Comments on applications for referral under the COVID-19 Recovery (Fast-track Consenting) Act 2020

RE: COVID-19 Recovery (Fast-Track Consenting) Act 2020 – Selfs Road, Papatoetoe Project – Comments sought

The application to Ministry for the Environment is made by Acanthus Limited and is located at 1 Selfs Road, Papatoetoe, Auckland (Lot 1 DP 503731).

GIS screenshot showing the proposed development's site and the water extensions and upgrades

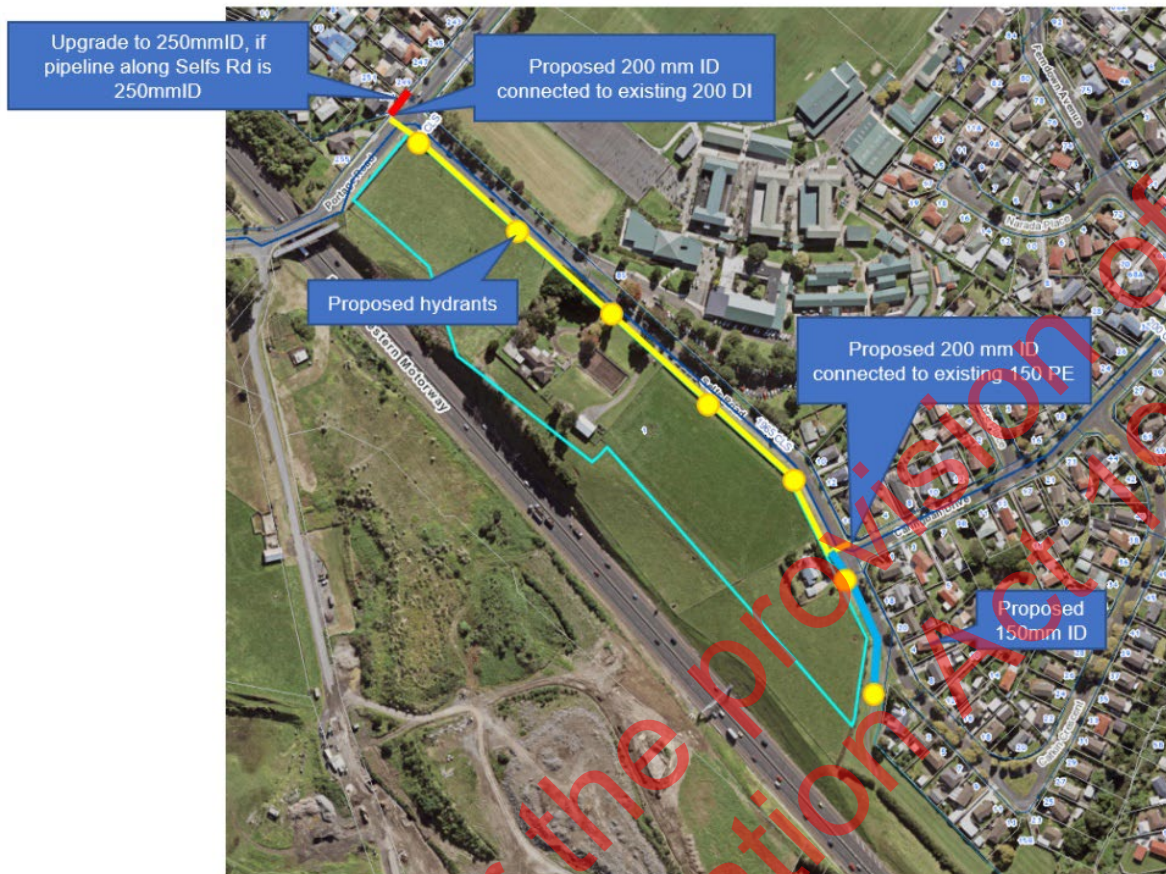
There is no watermain available in the southern part of Sels Rd close to the development. Based on a high-level flow estimation, Watercare's model predicts that the water network is currently operating near its capacity; therefore, the proposed development will trigger a requirement for a significant local network extension.

Overall, watermain pipe upgrades and extensions would be required as per the information below:

- Three points of connection to the existing watermains are on Portage Road (250mm ID), Caringbah Rd (200mm ID) and Sels Rd (150mm ID).
- Pipe upgrades and extensions for water connections and firefighting requirements would be required as shown below.

The developer must carry out the upgrades and extensions based on the agreed solution at no cost to Watercare.
